# HIGHWAY WORK PROPOSAL

<u>COUNTY</u>	<u>STATE PROJECT</u>	<u>FEDERAL</u>	<u>PROJECT DESCRIPTION</u>	<u>HIGHWAY</u>
Chippewa	7070-06-72	N/A	Augusta - Cadott; Eau Claire/Chippewa Co Ln to STH 29	STH 027

Addendum No. 02  
 ID 7070-06-72  
 Revised Sheet 1  
 November 30, 2023

Addendum No. 02  
ID 7070-06-72  
Added Sheet 4A  
November 30, 2023

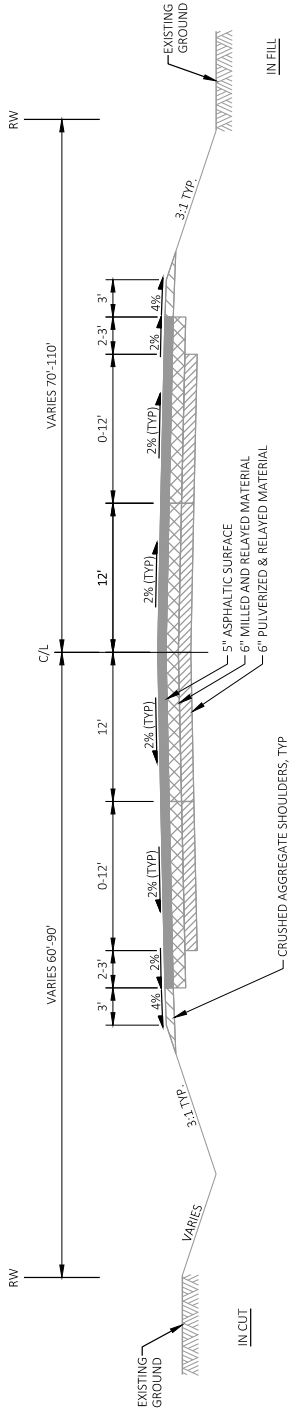
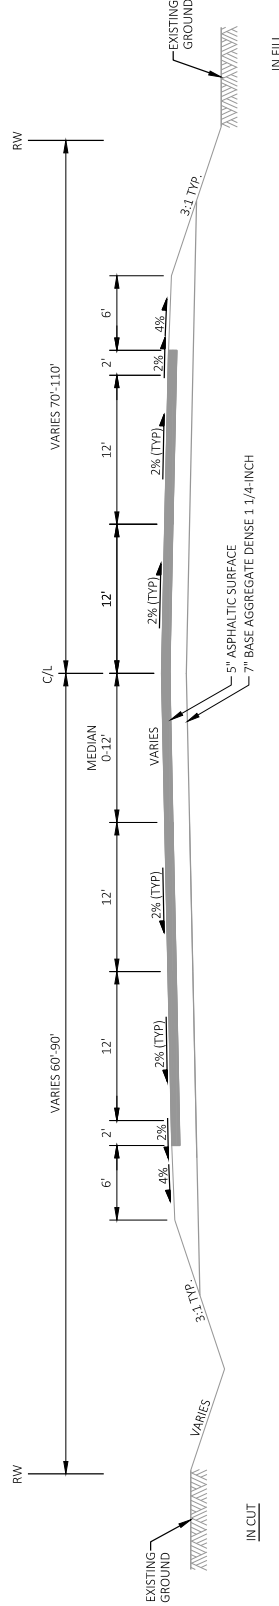
EXISTING TYPICAL SECTION - MILL

EXISTING TYPICAL SECTION - MILL

Addendum No. 02  
ID 7070-06-72  
Added Sheet 5A  
November 30, 2023

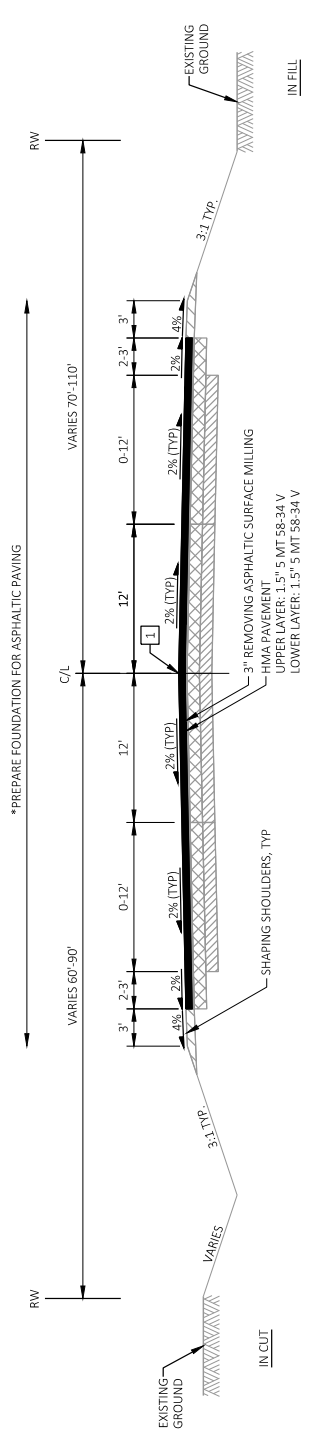
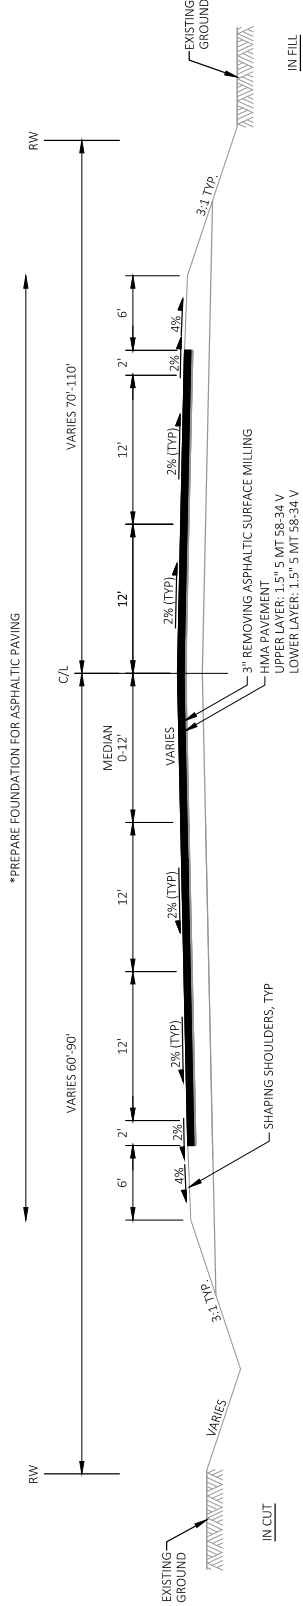
**FINISHED TYPICAL SECTION - MILL**  
STA 288+45 TO 296+88

**FINISHED TYPICAL SECTION - MILL**  
STA 296+88 TO 298+91

- 1 ASPHALTIC RUMBLE STRIPS, CENTERLINE
- \* PREPARE FOUNDATION FOR ASPHALTIC PAVING BY MILLING EXISTING ASPHALT TO PROPOSED EDGE OF ASPHALT.
